Report - Coastal & Flood Projects Department

Proposed Development:DISTILLERY WALK APARTMENTS - MIDLETONLocation:Distillery Walk, Midleton, Co Cork

1. Scope of Report

Figure 1 Site Location

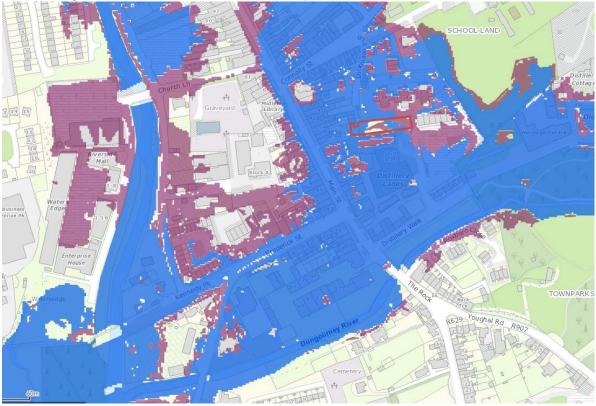
The proposed development is located on Distillery Lane, off Main Street. The site is located away from the river edge. In terms of the scheme, the development is located in Area 3 North..

The site is located in Flood Zone A (blue) and Flood Zone B (purple) as shown in the screenshot below.
